STAFF REPORT
COMMUNITY DEVELOPMENT DEPARTMENT

HEARING DATE: 4/28/2022
 TO: Planning & Zoning Commission
 FROM: Joe Dodson, Associate Planner
 208-884-5533
 SUBJECT: H-2022-0014
 Grayson Subdivision
 LOCATION: Located at 1710 E. Amity Road, near the northeast corner of E. Amity Road and S. Locust Grove Road, in the SW 1/4 of the SW 1/4 of Section 29, Township 3N, Range 1E.

Request for Annexation and Zoning of 3.39 acres from RUT to the R-8 zoning district and a Preliminary Plat consisting of 15 single-family residential building lots and 3 common lots on 3.1 acres of land in the requested R-8 zoning district, by Schultz Development, LLC.

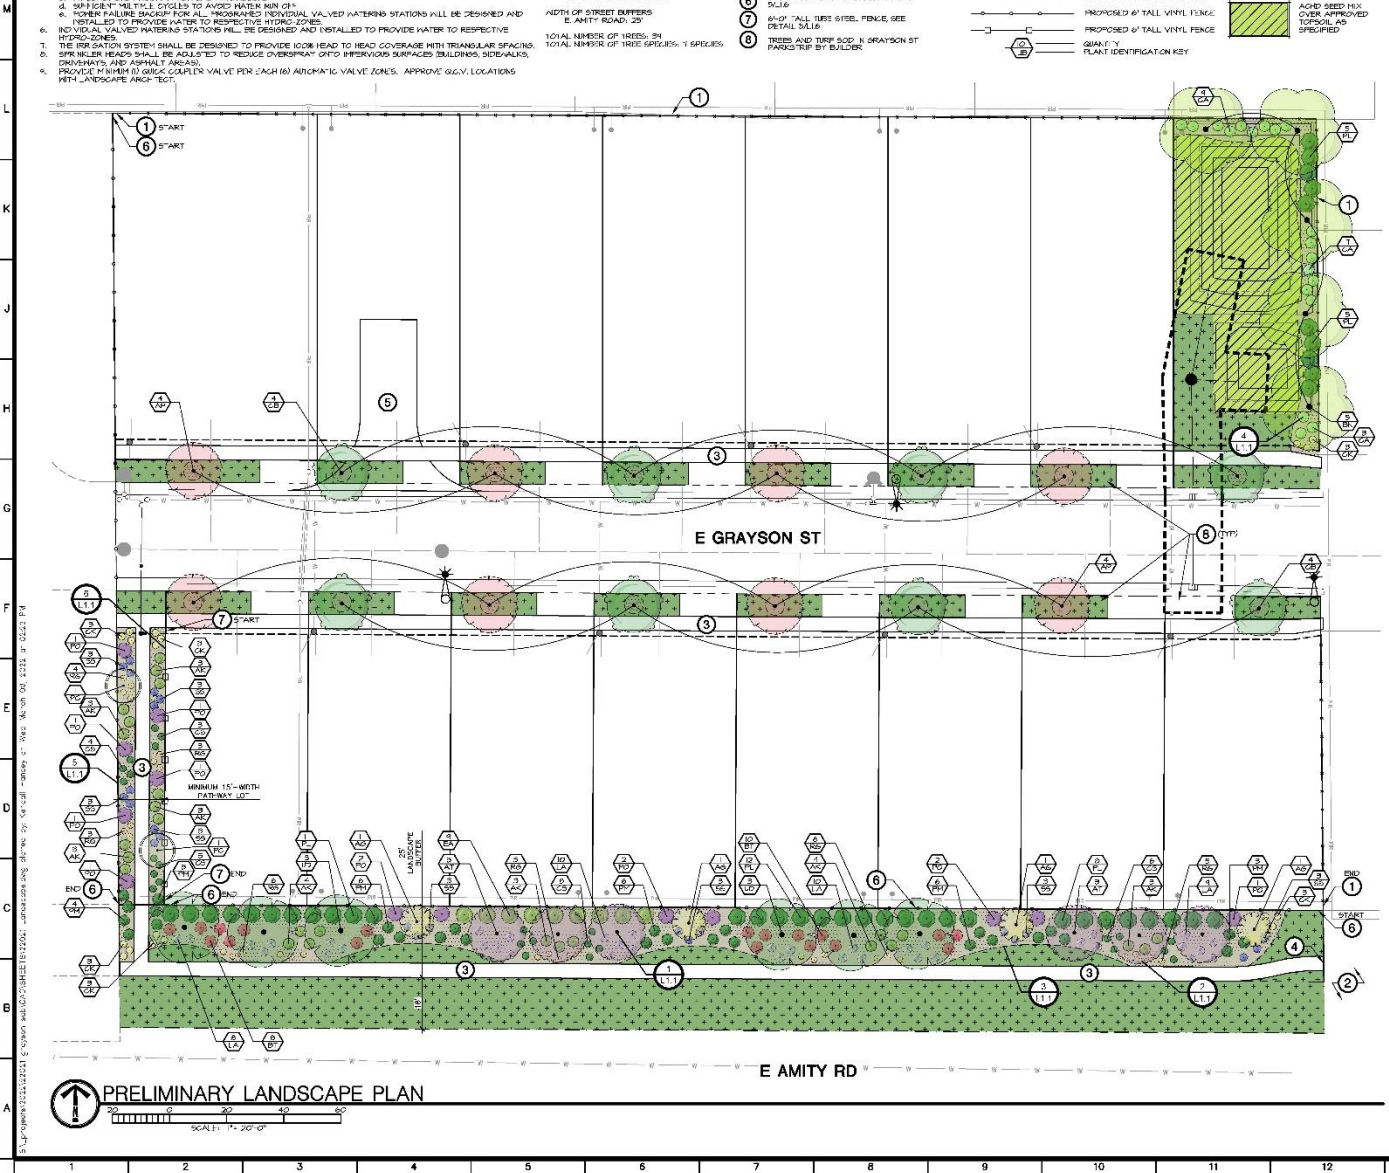
The Applicant has proposed a 5-foot wide detached sidewalk within the Amity Road street buffer which does not comply with this requirement. Therefore, Staff is including a condition of approval for the Applicant to revise the landscape plans to depict the required regional pathway within this buffer. Furthermore, this pathway should be at least four (4) feet north of the ultimate right-of-way line to allow for landscaping on both sides of the pathway and ensure the pathway is detached from the roadway and allow the 25-foot buffer to be measured from the ultimate right-of-way instead of the back of the pathway, per UDC 11-3B-7C.1a.

The Applicant is showing a 25-foot wide common lot with 16 trees, multiple landscape beds, and other vegetative ground cover along E. Amity; this proposed landscaping complies with UDC requirements. The micro-path lot is 15 feet wide and is depicted with two (2) trees which exceeds the minimum ratio in code of 1 tree per 100 linear feet as the pathway lot is approximately 100 feet long.

As noted above, the proposed 8-foot wide parkways do not appear to depict the correct number of street trees. Each parkway is approximately 420 feet long which requires a minimum of 12 trees on each side of Grayson Street. The submitted landscape plans depict 8 trees within each parkway so an additional four (4) trees are needed on each side of the street. Staff is including a condition of approval consistent with this requirement.

4. The preliminary plat included in Section VII.B, dated February 17, 2022, is approved as submitted.
5. The landscape plan included in Section VII.C, dated March 9, 2022, shall be revised as follows prior to submitting for Final Plat approval:

- a. Depict the correct number of street trees within the parkway per UDC 11-3B-7.
 - b. Add seating and a shade structure within the drainage common lot (Lot 1, Block 1).

- c. Depict the required 10-foot wide regional pathway within the Amity Road landscape buffer and place it at least four (4) feet north of the ultimate right-of-way line to allow for landscaping on both sides of the pathway and ensure the pathway is detached from the roadway and allow the 25-foot buffer to be measured from the ultimate right-of-way instead of the back of the pathway, per UDC 11-3B-7C.1a.

- d. Common Lot 1, Block 1 shall meet minimum standards in UDC 11-3B-11.
 - e. Common Lot 9, Block 2 shall be landscaped as proposed.

E. Temporary Turnaround Options – West terminus of E. Grayson Street extension

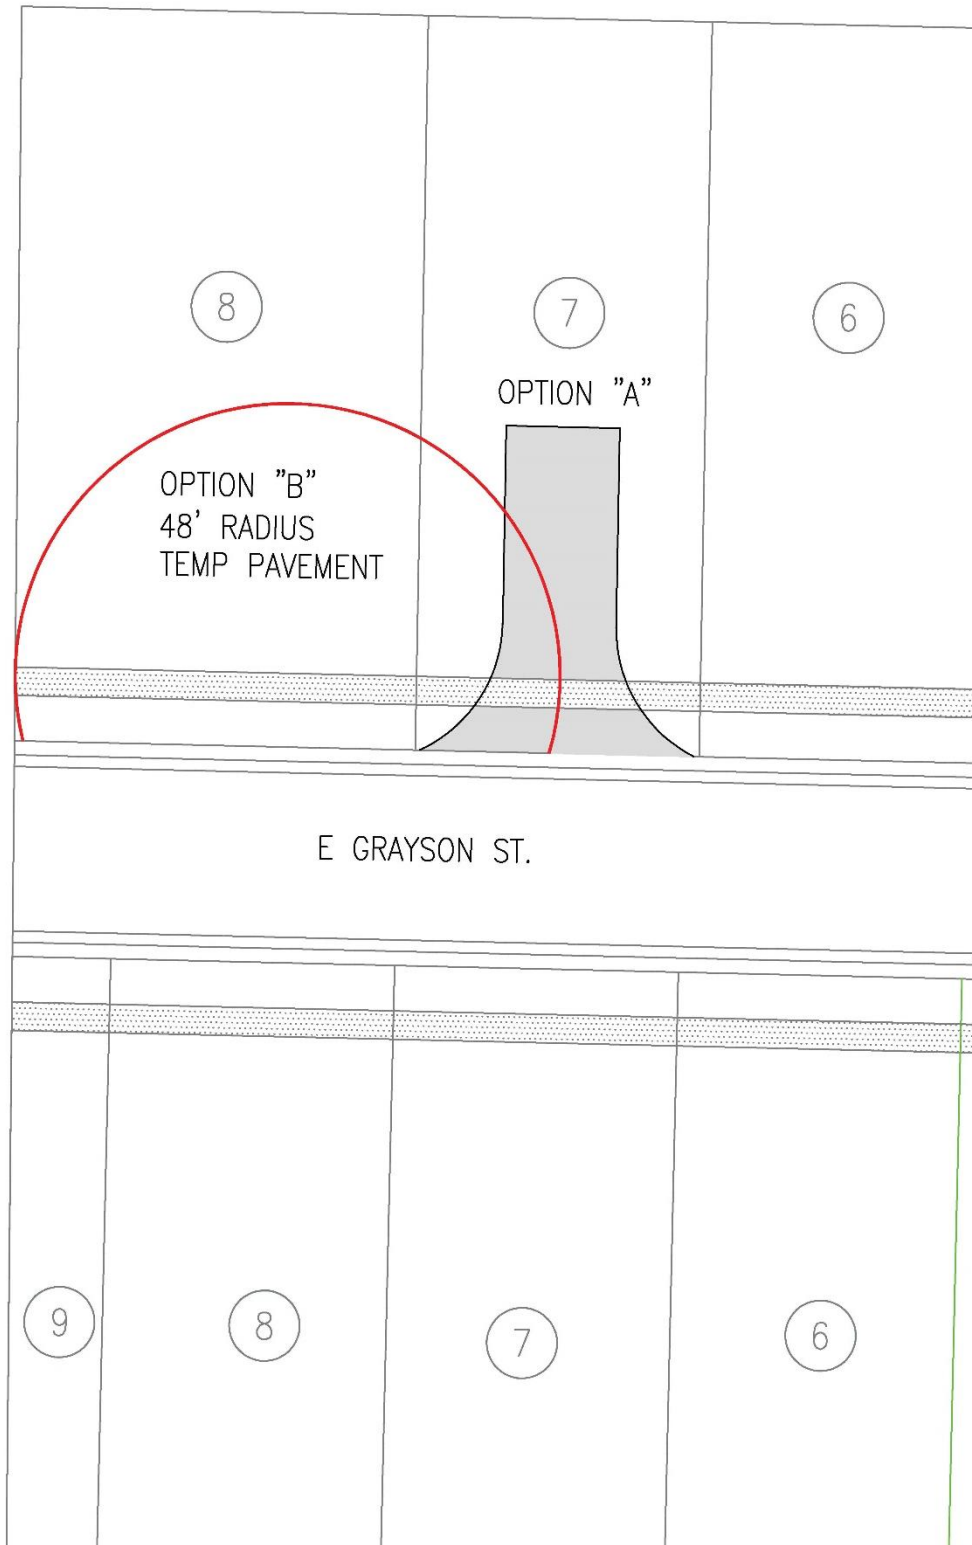
In addition to these elements, the proposed termination of the Grayson Street extension should be discussed. Specifically, this Applicant has proposed to stub Grayson to the west boundary as required by ACHD and the UDC but is showing a temporary hammerhead-type turnaround that encumbers a building lot, Lot 7, Block 1. Typically, ACHD has not allowed this type of turnaround in recent years, even on a temporary basis. The Fire Department and Planning Staff support the proposed design as it meets Fire requirements and does not make two future lots non-buildable for the near future. However, Staff anticipates ACHD will not approve this temporary turnaround. So, the Applicant has provided an exhibit showing Lots 7 & 8, Block 1 encumbered by an offset cul-de-sac as an alternative temporary turnaround should ACHD not allow the hammerhead. See snip below and Exhibit VII.E for this proposal:

Access is proposed via extension of E. Grayson Street (an existing residential local street) into the site and is proposed to terminate within the site at the west boundary for future connectivity. As discussed above, the Applicant is proposing to provide a temporary hammerhead-type turnaround instead of a temporary cul-de-sac. Staff supports this temporary turnaround design in order to save space and minimize the waste of asphalt within this development but anticipates ACHD will not approve this type of temporary turnaround. **If ACHD does not approve the hammerhead design as recommended by Staff, the applicant shall restrict Lots 7 and 8 as non-buildable lots as proposed and place a note on the final plat stating these lots will be developable with the extension of the public street.**

2. The applicant is seeking a Council waiver for E. Grayson Street to be a dead-end street greater than 500 feet in length, per UDC 11-6C-3B.4.
3. Per Exhibit VII.E attached hereto, E. Grayson Street shall terminate along the west property boundary as either a temporary cul-de-sac or hammerhead type turnaround—if a hammerhead type turnaround is approved by ACHD, Lot 7, Block 1 shall be a non-buildable lot until such time as Grayson is further extended; if a cul-de-sac turnaround is required, Lots 7 & 8, Block 1 shall be non-buildable lots until such time as Grayson is further extended.
